**HIROSE ELECTRIC CO., LTD.**

## TM5RJ and TM5RJ2 Series Notification of Change to the Board Hold-downs (Bosses)

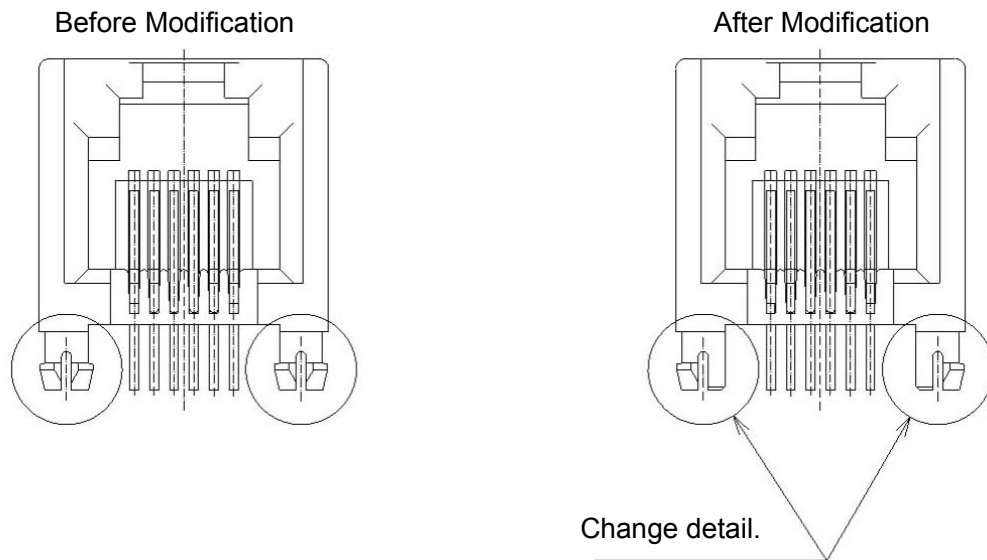
The form of the bosses will be changed as illustrated in the diagrams below.

The form of the boss will be changed to reduce insertion force into the board and to improve workability.

There will be no effect on product performance. Also, there will not be any change from the existing board installation dimensions.
